A47 North Tuddenham to Easton

Scheme Number: TR010038

**9.2 Applicant's Response to
Relevant Representations**

Rule Number:	3(2)(b)
Planning Inspectorate Scheme Reference	TR010038
Application Document Reference	TR010038/EXAM/9.2
BIM Document Reference	HE551489-GTY-LSI-000-RP-TX-40001
Author:	A47 North Tuddenham to Easton Project Team, Highways England

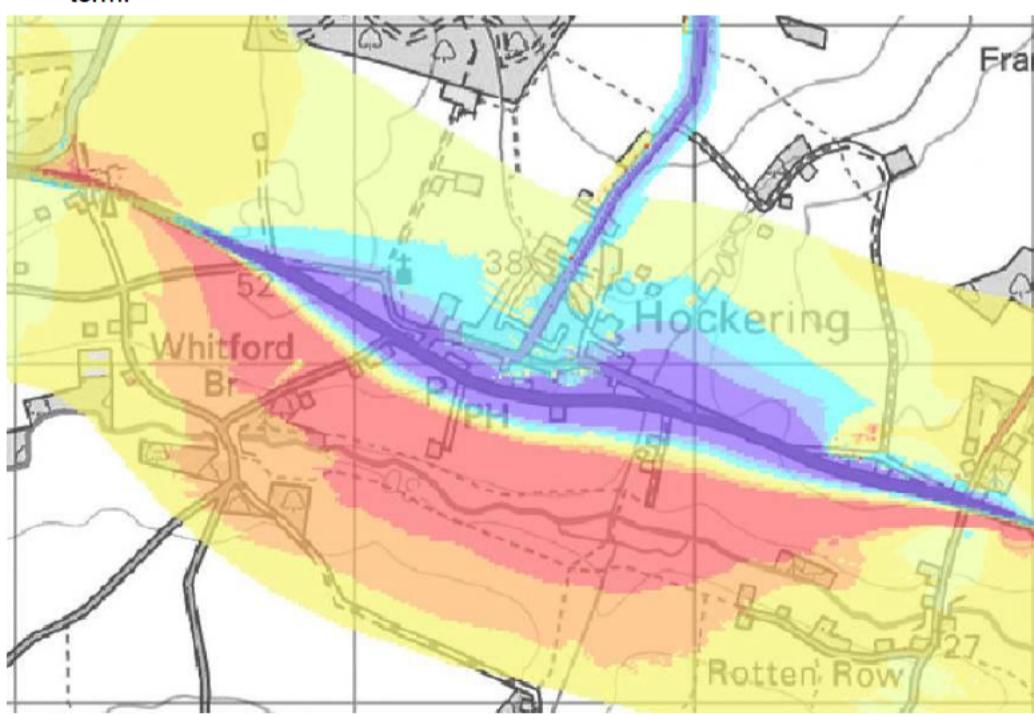
RR-016.2	<p>Revised plans submitted to Inspectorate</p> <p>We note the latest plans that have been submitted. At this stage, we note that HE's 'Environmental Management Plan' includes the following commitment:-</p> <p>In support of limiting and controlling noise during construction, the PC [Principal Contractor – Galliford Try] may use, inter alia, the following good working practices to minimise potential impacts:</p> <p>Restrict construction working hours to 07:00-19:00 on weekdays and 07:00-19:00 on Saturdays as far as practicable. Night-time and weekend working hours to be determined in discussion with the LPA (including Section 61 prior consent applications where necessary).</p> <ul style="list-style-type: none"> Temporary noise barriers at specific construction phases and receptors as detailed in Table 11.11 in Chapter 11 of the ES (TR010038/APP/6.1) and summarised below: - Stage 1 (Pre-construction works) - [REDACTED] <p>We believe the commitment is fairly woolly and could be improved upon, e.g. by excluding or restricting Saturday working if residents will be in occupation and affected by the</p>	<p>The Applicant acknowledges Childhood First's concerns and has consulted National Grid Gas Plc (NGG) on the below responses to the points raised.</p> <p>Working hours</p> <p>With regards the working hours, the Applicant is unable to exclude Saturday working for several reasons:</p> <ul style="list-style-type: none"> There will need to be a period of 24-hour continuous activity lasting for between a week and upwards of a month during the drilling works to install the pipeline under the A47. This is because the pipe pull through cannot be stopped once started, as stopping the pull through risks the apparatus becoming stuck. Though efforts would be made to minimise the need to work weekends, there may be occasions where the benefits of excluding or restricting Saturdays may be offset by a longer presence of construction on site to offset the loss of Saturday working. In some cases, the Applicant or NGG may wish to utilise the good weather and long summer days to accelerate completion of work, so as to reduce the number of days of potential disturbance. Finally, should there be 'heat wave' conditions, working days or daily hours may be carried out at cooler times to reduce the impact on the welfare and safety of the construction workforce. Such an arrangement would only be

Reference	Relevant Representation	Highways England Response
	<p>works. Looking at the points raised in the meeting notes, there may be further scope for minimising the impact of the utility diversion works on [REDACTED], for example a commitment that the mud mixer will be positioned so as to cause minimum inconvenience and to restrict sheet piling operations to certain times of day (e.g. avoiding early mornings and evenings).</p>	<p>undertake after prior engagement with affected neighbouring properties. However, the nature of the works means there may be periods of reduced or quieter activity, such as during the testing stage, when restricted working hours may be feasible.</p> <p>Therefore, the Applicant and NGG are committed to continuing regular, on-going communications with Merrywood House prior to and during construction to minimise the disturbance and risks to the occupants of Merrywood House. Through this process the Applicant would seek to identify: opportunities for more disturbing activities to be programmed for less sensitive periods; periods when it may be suitable and feasible to restrict working hours; or where the activities would involve a low risk of disturbance. Action G7 in the Environmental Management Plan (APP-143) confirms the commitment to engage with local residents to provide prior notification of and manage concerns about periods of disruption; delivery of this commitment will be secured through dDCO Requirement 4 'Environmental Management Plan' (APP-017).</p> <p>Position of plant and equipment</p> <p>Utility diversion and drilling contractors have not yet been appointed, so the Applicant is unable to confirm the future position of any plant and equipment within the field north of Merrywood House.</p> <p>However, when appointed the contractors will be required to adhere to commitments to minimise disturbance to Merrywood House detailed in the Environmental Management Plan (APP-143). Through dDCO Requirement 4 'Environmental Management Plan' (APP-017), the relevant planning authority is to be consulted on the second iteration of the Environmental Management Plan (APP-143) and the Applicant proposes to include measures such as.:</p> <ul style="list-style-type: none"> • accessing the field from Berrys Lane as far north as possible without impacting the woodland north of the field; • placing other activities as far as possible away from Merrywood House, such as far north within the field as feasibly possible; and • installing a temporary noise barrier along the southern side of the works area, which will also provide a visual screen. <p>The Applicant and NGG are also committed to continuing regular, on-going communications with Merrywood House prior to and during construction to minimise the disturbance and risks to the occupants of Merrywood House. Affected landowners and neighbouring properties will be notified of the communications arrangement for those interested parties to liaise with the Applicant or NGG accordingly. These commitments will be delivered through the above Action G7 in the Environmental Management Plan (APP-143).</p>

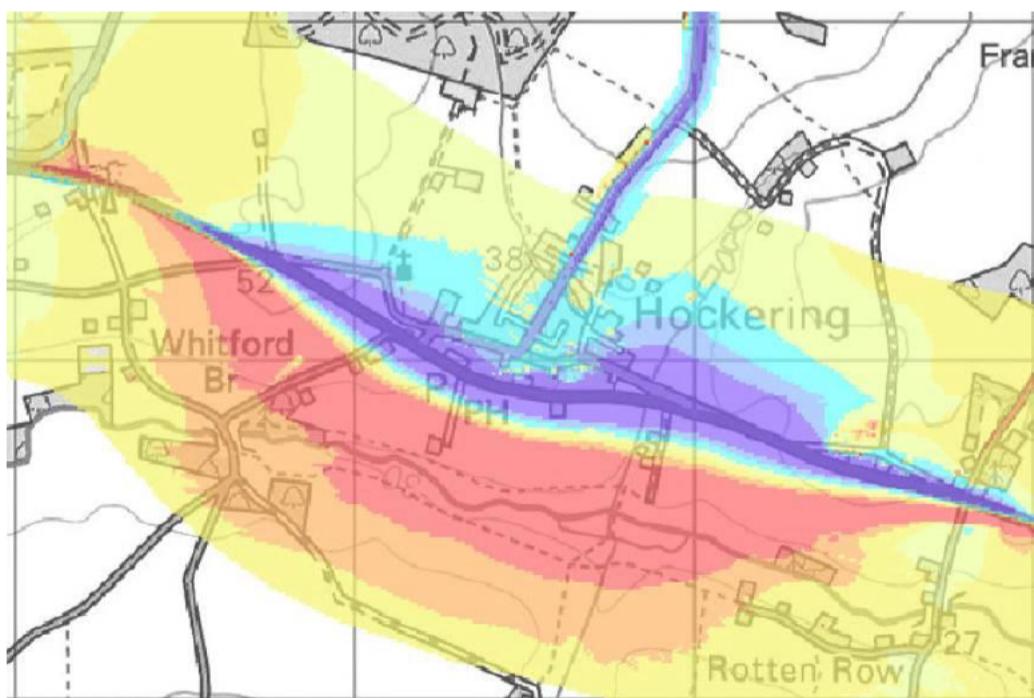
Reference	Relevant Representation	Highways England Response
RR-051.1	<p>We are concerned that the Ecological Assessment of the proposed scheme does not adequately consider the short and long-term impacts on the nationally important colony of Western Barbastelle <i>Barbastella barbastellus</i>, a rare Annex II bat species which is located in the Lenwade/Ringland Hills/Weston Longville area.</p> <p>The cumulative impacts of this scheme and the Norwich Western Link are not addressed, despite the fact that both schemes fall within the Core Sustenance Zone of the barbastelle colony.</p> <p>On-going comprehensive research on this colony by Wildwings Ecology, in collaboration with the University of East Anglia and the Norfolk Barbastelle Study Group, has shown that barbastelles from the colony cross the A47. To our knowledge, there has been no attempt to consider this information in the impact assessment.</p> <p>The dualled road corridor road will considerably increase the risk of road kills and habitat severance which, together with the adverse impacts from the Norwich Western Link, will have a major adverse impact on the long-term viability of the colony. There is no existing evidence to give confidence that green bridges, gantries or underpasses will successfully mitigate for these impacts.</p> <p>Although not designated, the barbastelle colony exceeds the criteria for Special Area of Conservation (SAC) designation. The national importance of the colony should not be ignored in the impact assessment.</p>	Please see Common Response I
